Response to RFI: #001 Biosphere Questions

Project: Renovate Rehabilitative Medicine

Project # 573A-12-101

4. Dwg. G103; General Notes; Note B identifies requirements for dust and debris requirements based on anticipated levels of dust generation: small projects of short duration; projects that generate moderate to high levels of dust and large dusty projects.

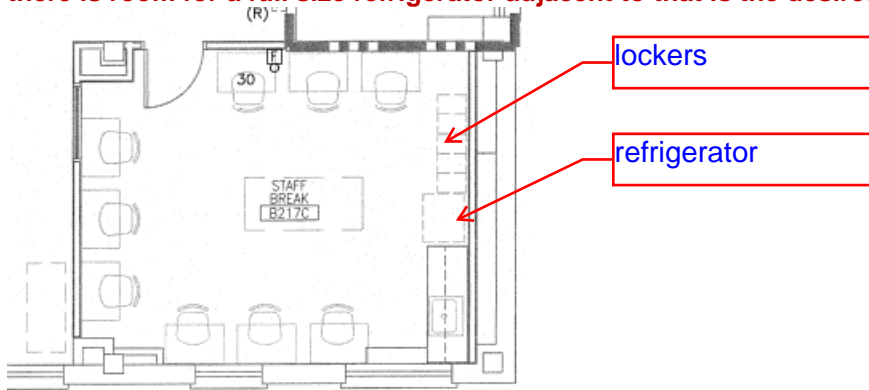
- Which requirement will be imposed on all the phases of this project?

Response: Please consult with VA COR for proper classification of project.

5. Dwg. AE101; Floor Plan

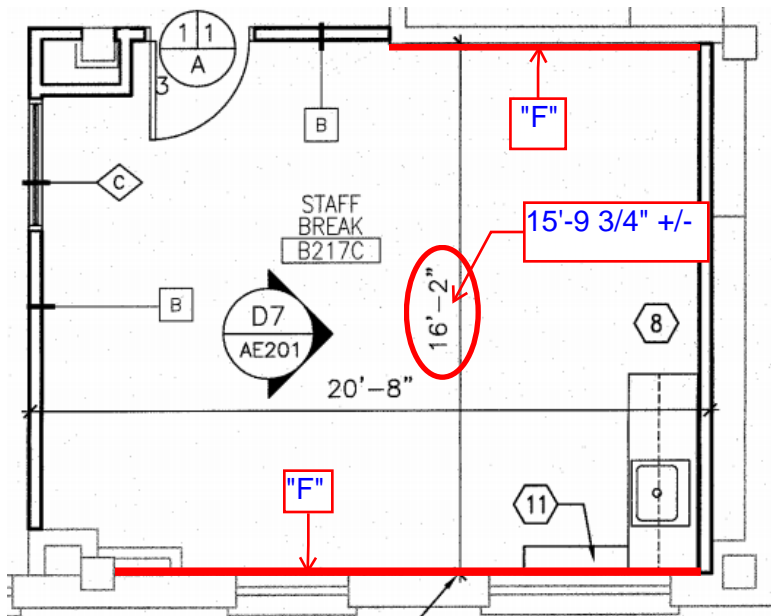
- The lockers are not shown in the Staff Break (B217C); can you confirm location?

- Where do Wall Types A and F occur?

Response: Below is a snapshot of the furniture plan for the Break Room. East of the counter there is room for a full size refrigerator adjacent to that is the desired locker area.

Response: Wall types "A" is not used. Furring wall type "F" shall be used in room B217C Staff break room on the west exterior wall. In addition, use wall type "F" at existing to remain east wall.

3. Dwg. A1101; Finish Floor Plan; Note 8

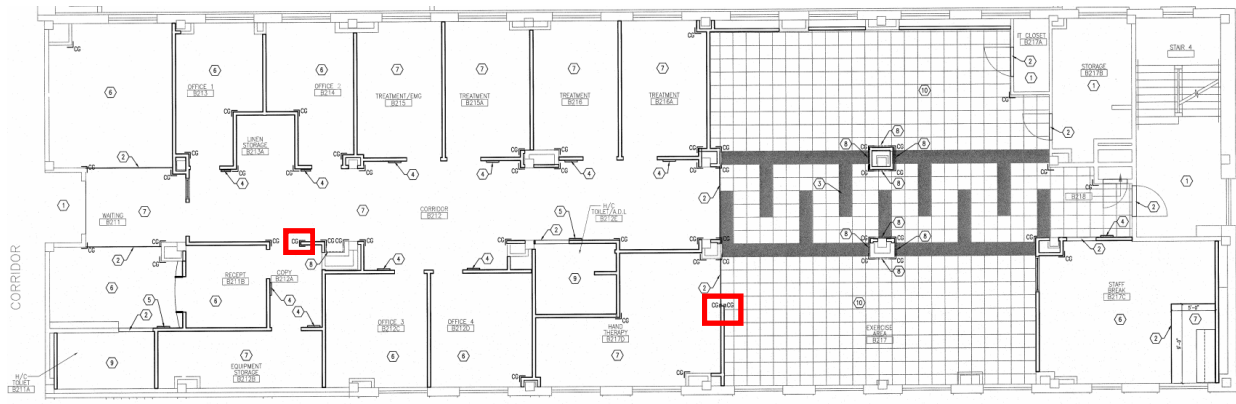
- Note 8 requires ceramic tile mosaic on all four sides of the columns but the height of the tile is not noted anywhere on the drawings. What is the height?

Response: The columns shall be clad full height in ceramic tile.
